RE: EWO – Olympic Steel (S20A0480A)

Nucor Building Systems has completed an engineering analysis of existing Nucor job #S08A0480A. The EWO included investigating the impacts of updating the building code to IBC 2018. The follow loads are as follows:

**CROSS SECTION @ LINES 10-18**

**CROSS SECTION @ LINES 5 & 8**

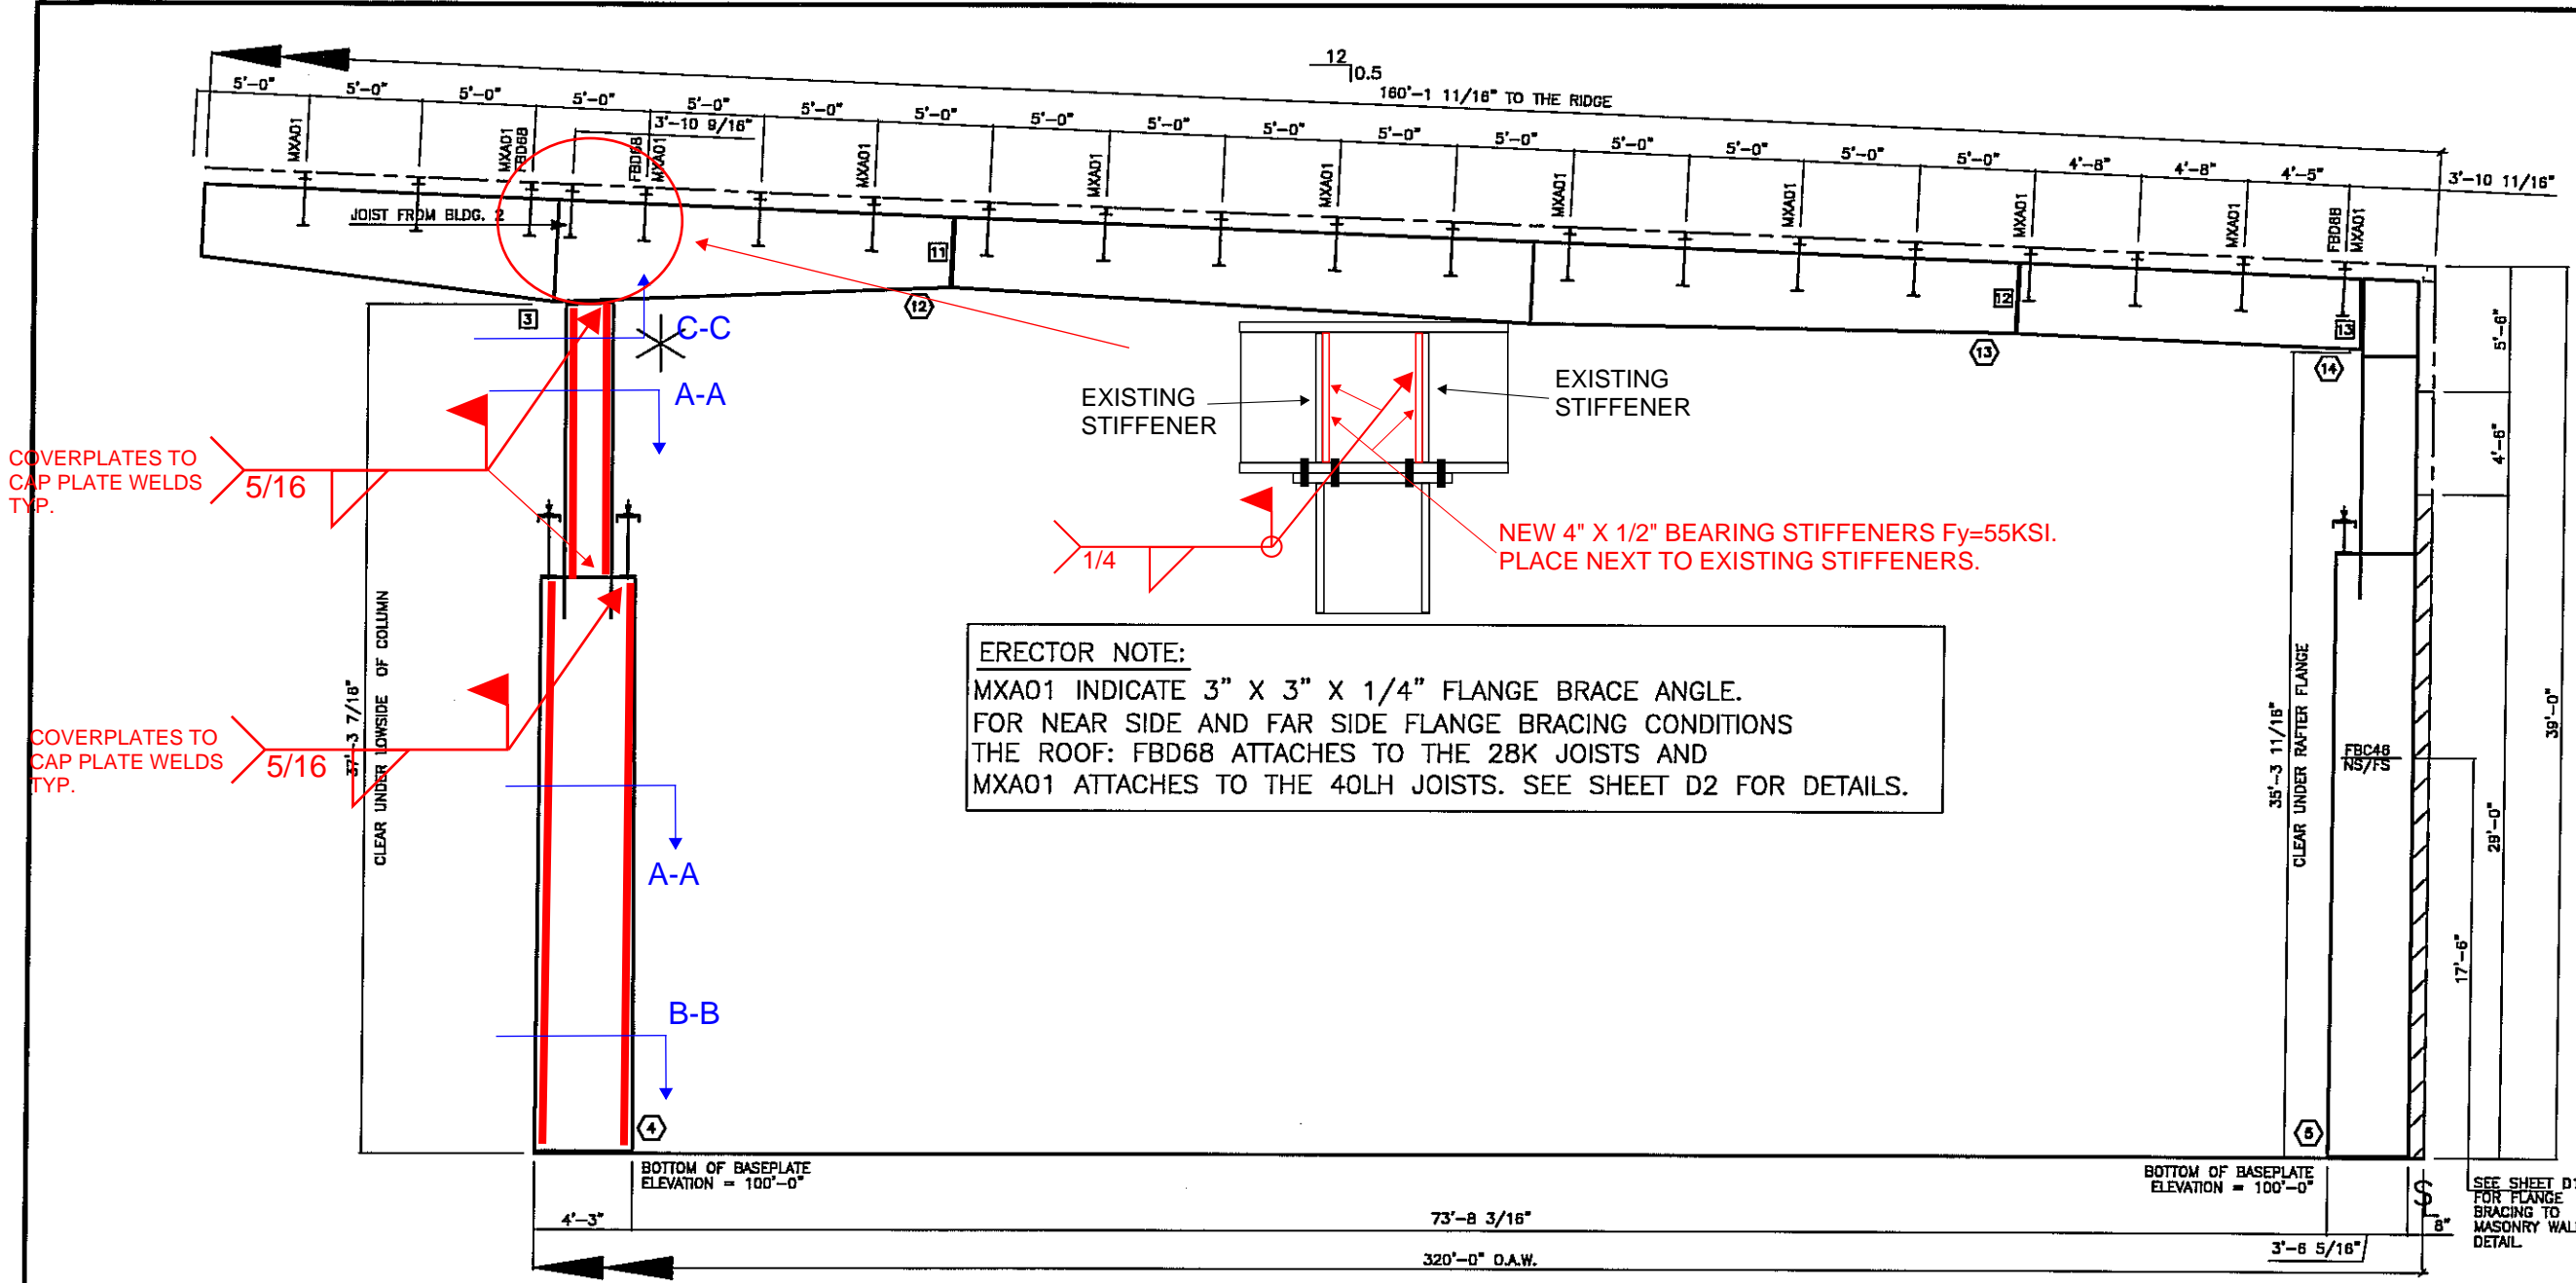
- 3) Frame lines 5-8 will require the following reinforcements:
  - a. The column flanges on lines E, J, and P will required cover plates.
  - b. The stiffeners in the fixed base connection will be field cut back to allow the cover plates to extend to the base plate.

- c. The moment connections above the columns on lines E, J, and P will require bearing stiffener reinforcements and additional holes will be field drilled into the connection for the attachment of additional bolts.
  - d. (2) Endplates per frame (10 total) will require bolt replacements.
  - e. See pages 8-10 for the fieldwork required.
- 4) A separate submittal from Vulcraft will be sent at a later date with the investigation results for the roof joist.

SECTION A-A  
FRAME COLUMN/RAFTER

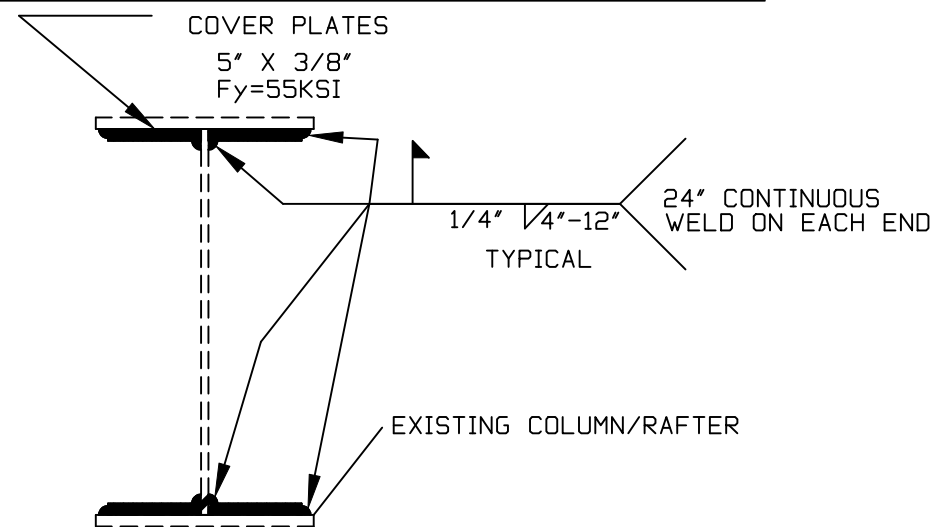
- 1) Frame lines 10-18 will require the following reinforcements:
  - a. The column flanges on lines E, J, and P will required cover plates.
  - b. The stiffeners in the fixed base connection will be field cut back to allow the cover plates to extend to the base plate.

SECTION C-C  
FRAME RAFTER TO COL/RAFTER CONNECTION  
NEW BOLTS

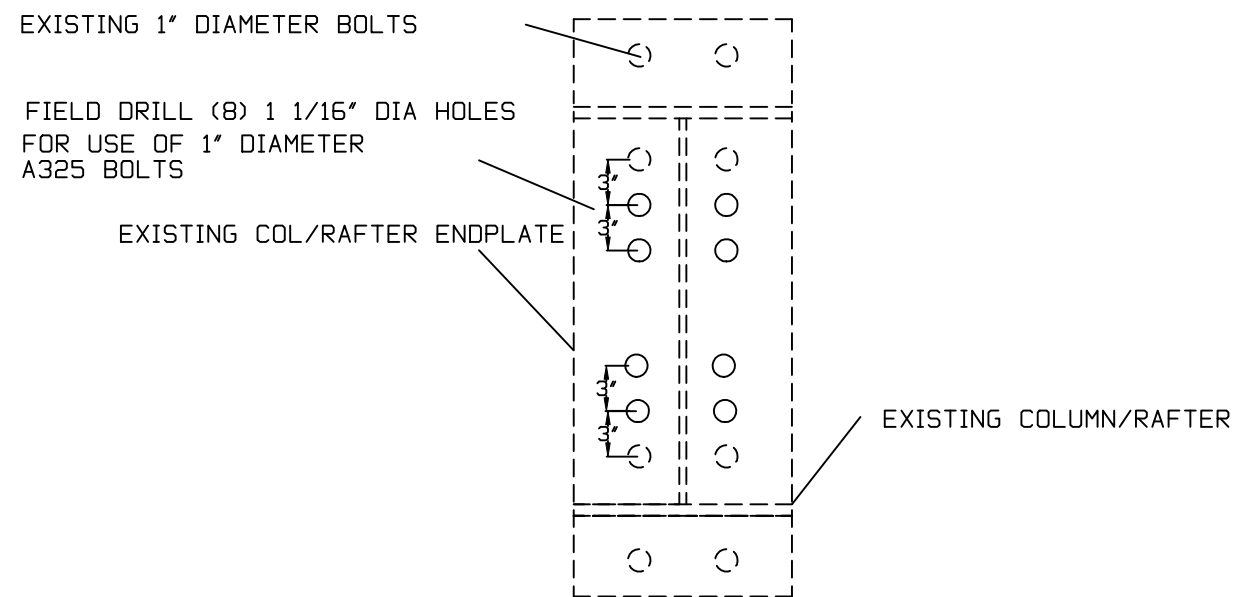
- c. The moment connections above the columns on lines E, J, and P will require bearing stiffener reinforcements.
  - d. (2) Endplates per frame (10 total) will require bolt replacements.
